**Response to**

**Request for Additional Information No. 221, Supplement 4**

**U. S. EPR Standard Design Certification**

**SRP Section: 06.02.01 - Containment Functional Design**

**Figure 06.02.01-42-1—Steam Generator Insulation Temperature Profiles**

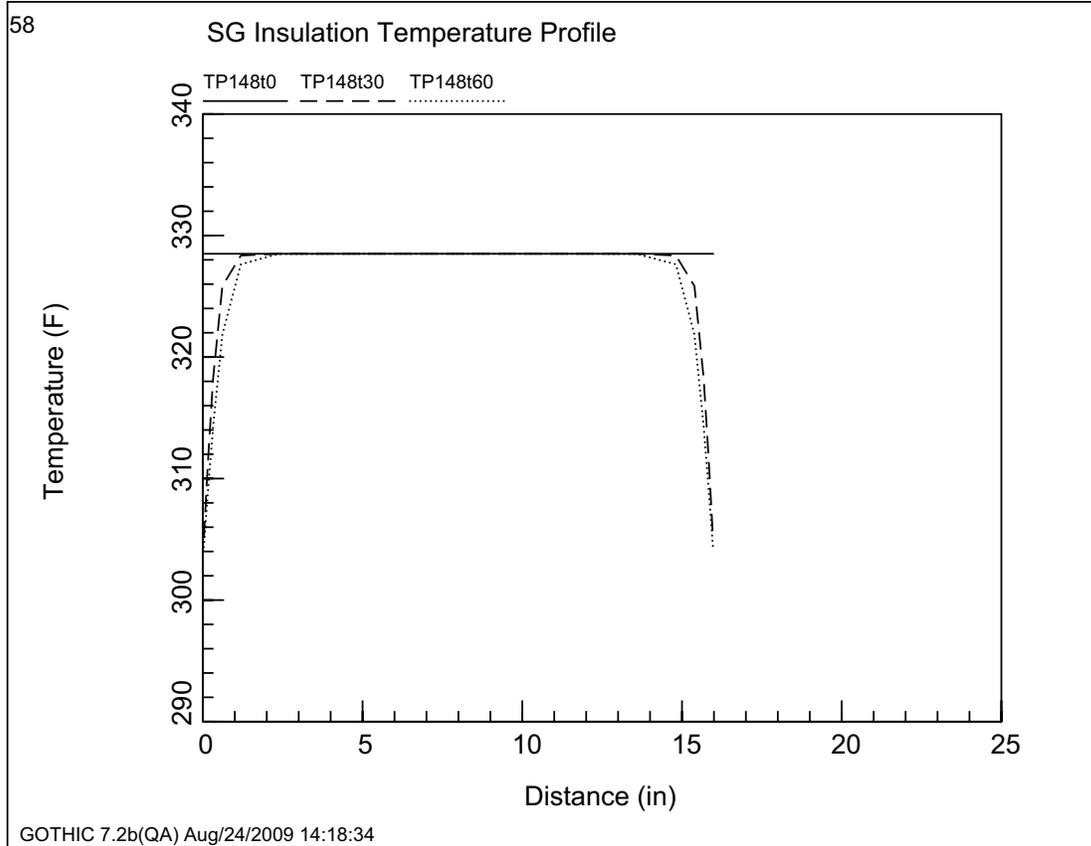
FSAR Section 5.2.3.4.3 documents that reflective metal insulation (RMI) will be used to cover the primary and secondary side system components. In Section 8.1.1 of ANP-10299P the energy sources for mass and energy discharge are discussed but RMI is not included. During LBLOCA or MSLB, some of the RMI insulation is expected to be detached so that the sensible heat from this RMI would be directly discharged to the containment while remaining intact RMI would contribute to the heat added to the containment. Provide an assessment of the effect of the addition of RMI sensible heat to the containment peak pressure and temperature following a LBLOCA or MSLB.
